Docket Nos. 50-280  
and 50-281 ✓

Tech. Spec. Change No. 6  
License Nos. DPR-32  
and DPR-37

In your letter of March 19, 1973 you advised us that Vepco planned to operate Surry Power Station, Units 1 and 2 in accordance with the Technical Specifications furnished in your report "Fuel Densification - Surry Power Station, Unit 1," dated December 1972. As part of our continuing review of the effects of fuel densification, we met with representatives of your staff and Westinghouse Electric Corporation on March 16, 1973 to discuss the adequacy of the Surry Units 1 and 2 Technical Specifications with respect to fuel densification. Subsequent to this meeting and upon further review of this matter, we have concluded that several changes to the Technical Specifications for Surry Power Station, Units 1 and 2 are necessary for further protection against the effects of fuel densification.

FIGURE 2.1-1  
SAFETY LIMITS REACTOR CORE  
THERMAL AND HYDRAULIC, THREE  
LOOP OPERATION, 100% FLOW

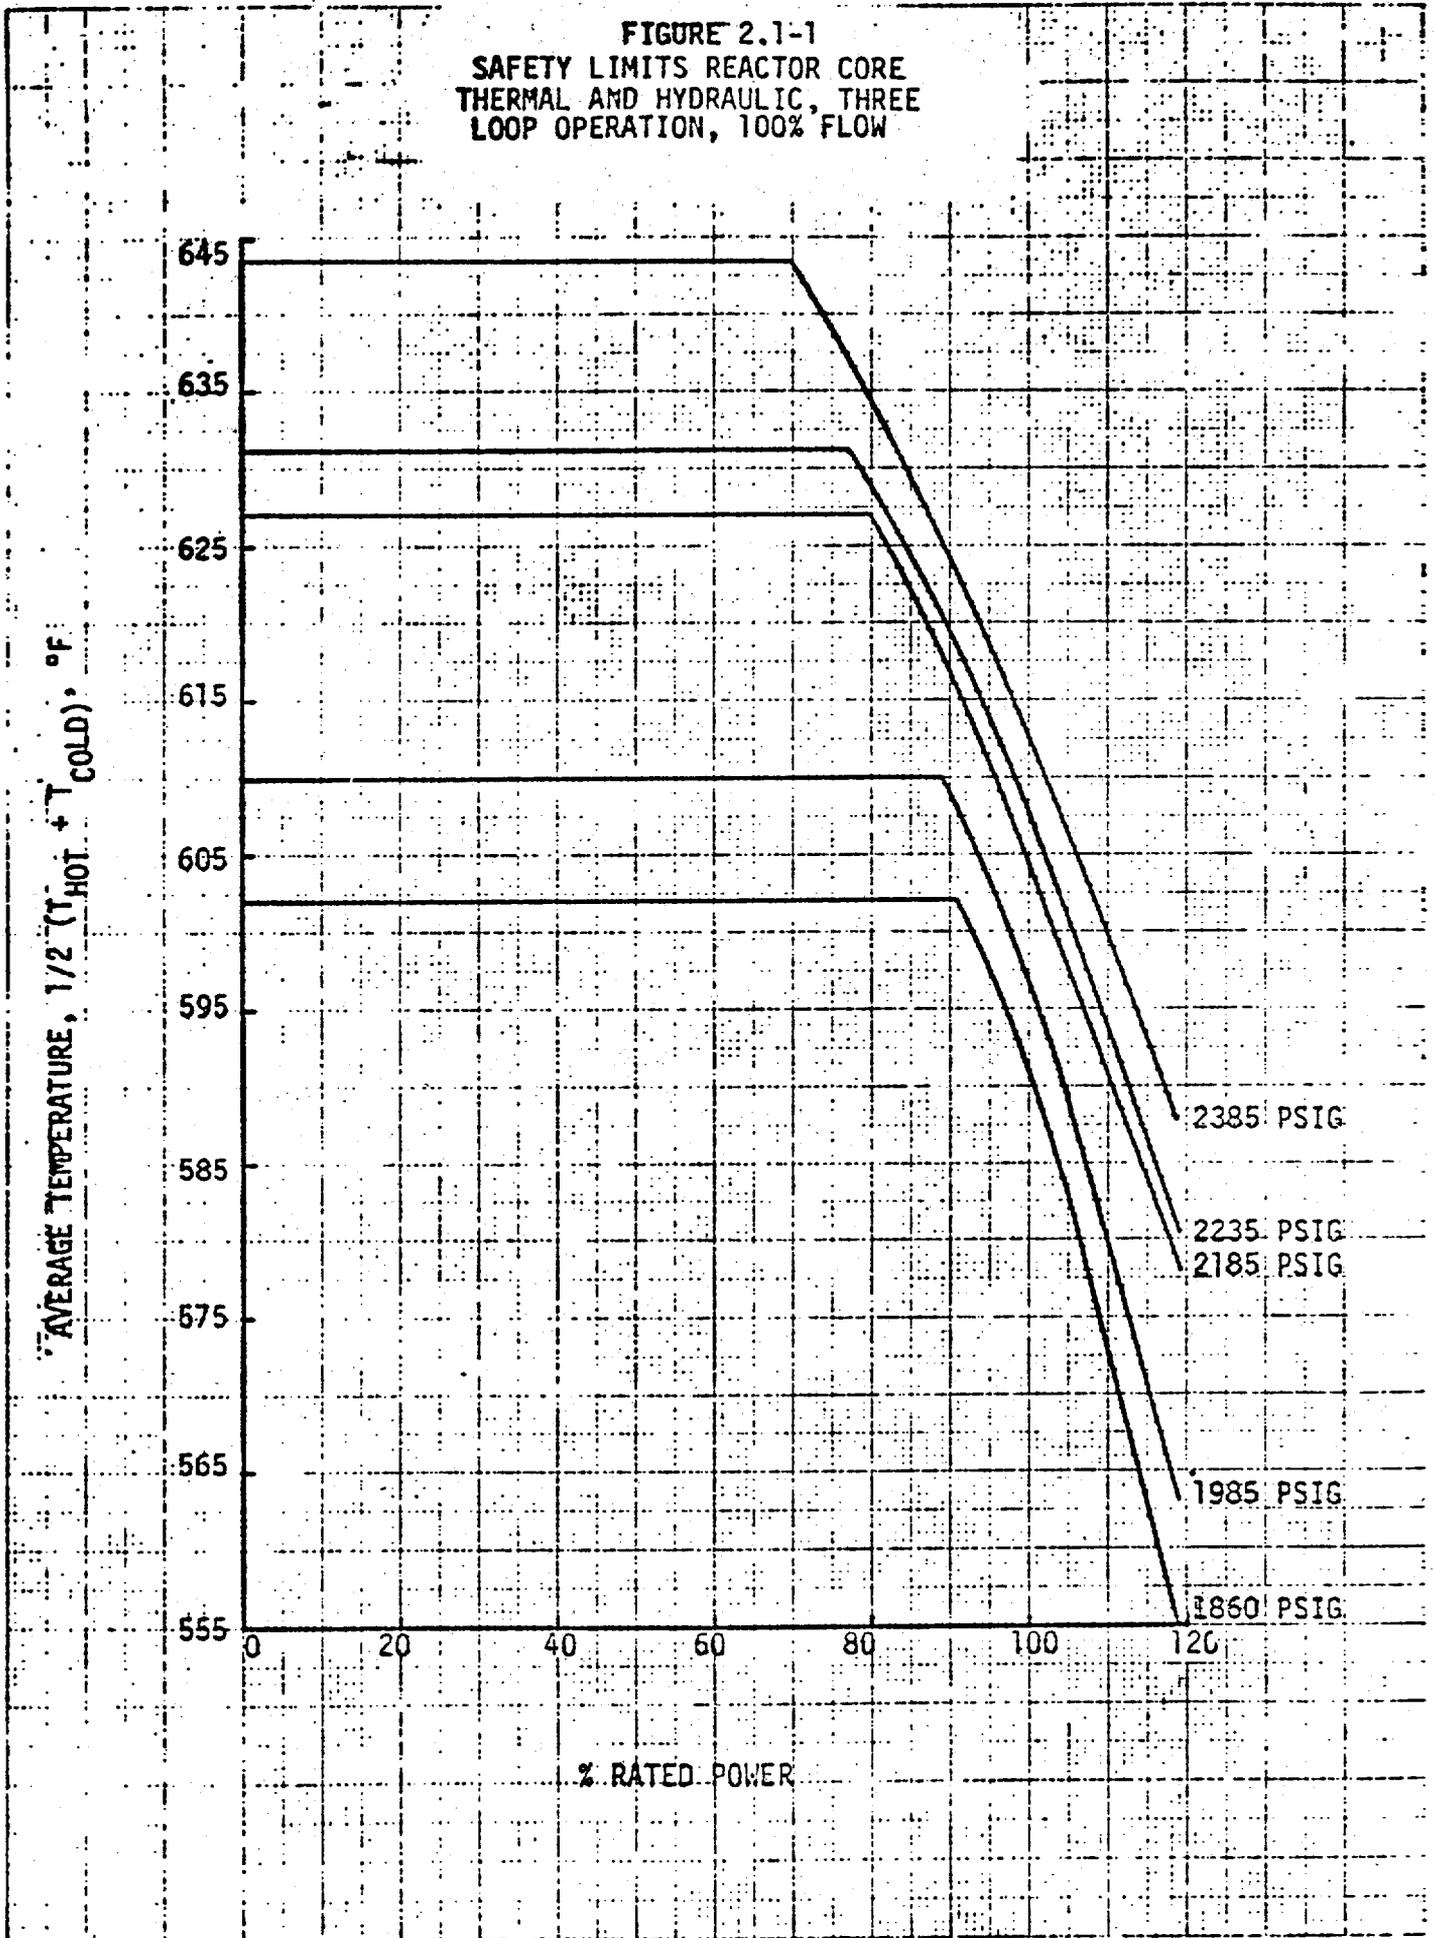
The curves of TS Figure 2.1-1 which show the allowable power level decreasing with increasing temperature at selected pressures for constant flow (three loop operation) represent the loci of points of thermal power, coolant system average temperature, and coolant system pressure for which the DNB ratio is not less than 1.30. The area where clad integrity is assured is below these lines. In order to completely specify limits at all power levels, arbitrary constant upper limits of average temperature are shown for each pressure at powers lower than approximately 75% of rated power. The temperature limits at low power are considerably more conservative than would be required if they were based upon a minimum DNB ratio of 1.30 but are such that the plant conditions required to violate the limits are precluded by the self actuated safety valves on the steam generators. The three loop operation safety limit curve has been revised to allow for heat flux peaking effects due to fuel densification.

power levels, arbitrary constant upper limits of average temperatures are shown for each pressure at powers lower than approximately 45% of rated power. The limits at low power as well as the limits based on the average enthalpy at the exit of the core are considerably more conservative than would be required if they were based upon a minimum DNB ratio of 1.30. The plant conditions required to violate these limits are precluded by the protection system and the self actuated safety valves on the steam generator. Upper limits of 70% power for loop stop valves open and 75% with loop stop valves closed are shown to completely bound the area where clad integrity is assured. These latter limits are arbitrary but cannot be reached due to the Permissive 8 protection system setpoint which will trip the reactor on high nuclear flux when only two reactor coolant pumps are in service. Additional peaking factors to account for local peaking due to fuel rod axial gaps and reduction in fuel pellet stack length have been included in the calculation of the curves shown in Figures 2.1-1, 2 and 3.

FIGURE 2.3-1

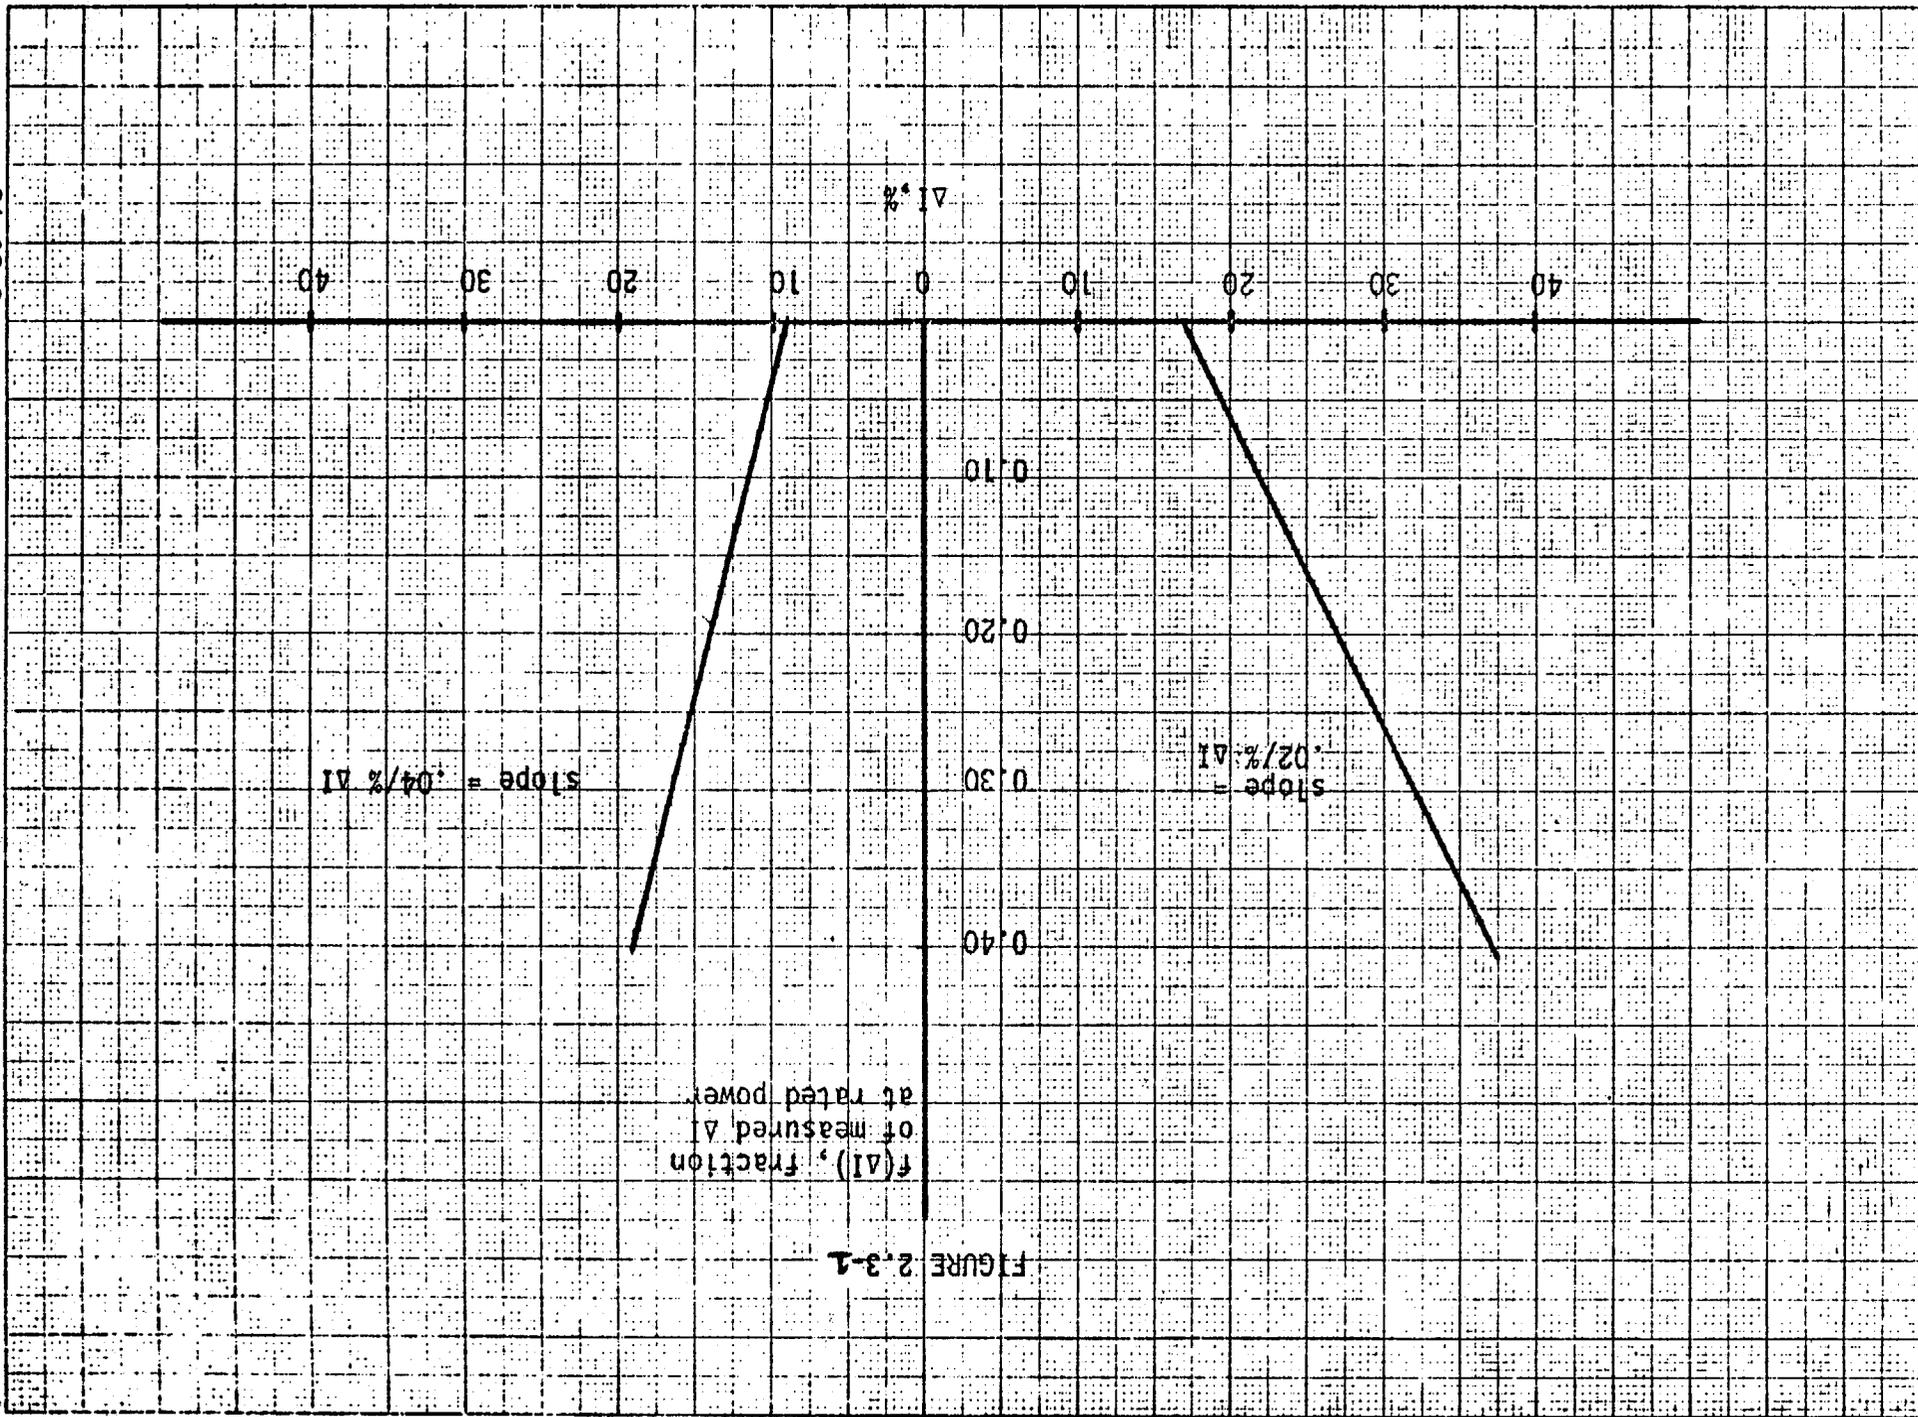
The overpower and overtemperature protection system setpoints have been revised to include effects of fuel densification on core safety limits. The revised setpoints in the Technical Specifications will ensure that the combination of power, temperature, and pressure will not exceed the revised

FIGURE 3.12-1

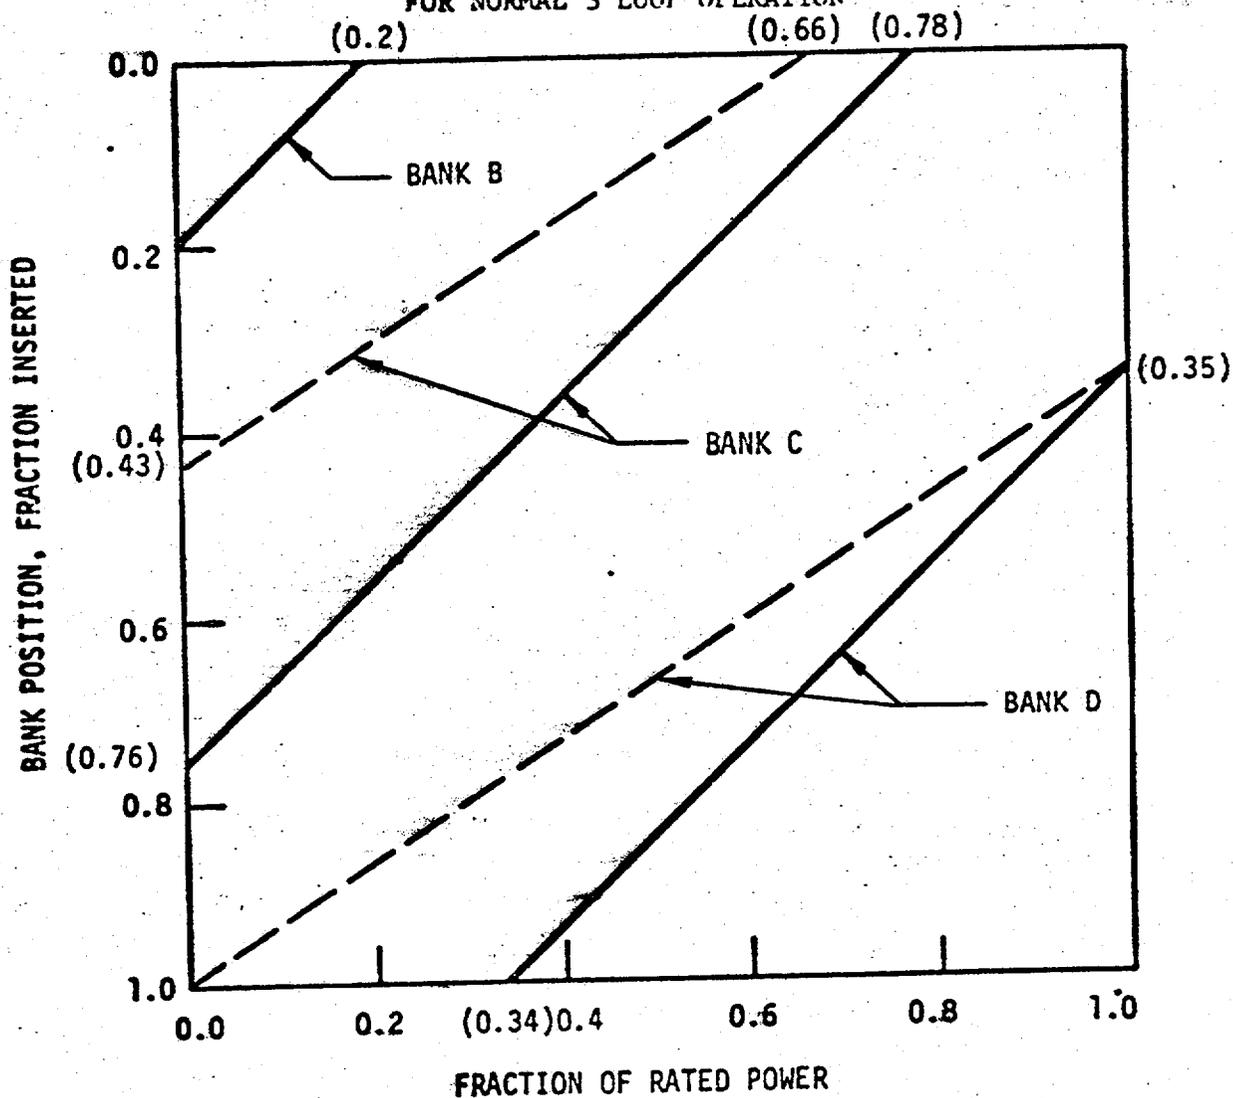
The specified control rod insertion limits have been revised to limit the potential ejected rod worth in order to account for the effects of fuel densification.
